Certificate of Appropriateness
1040 Williamson Street
August 16, 2021

Proposed Work

- Construct ADU on rear of property
 - First floor garage
 - Second floor living space

**CARRIAGE HOUSE
WEST ELEVATION**

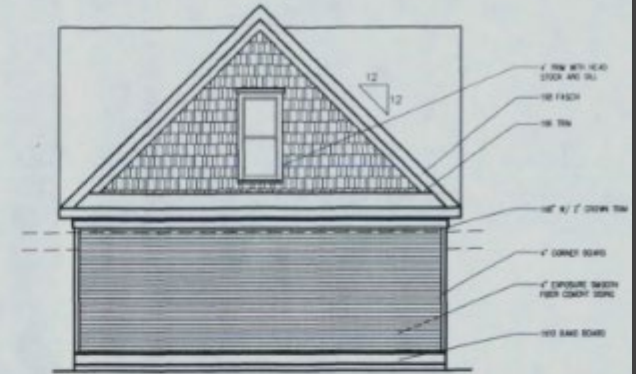
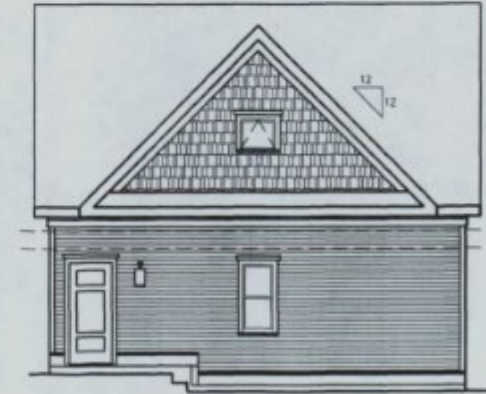
1. Extend clapboard siding to the first floor of the structure instead of the EIFS cladding
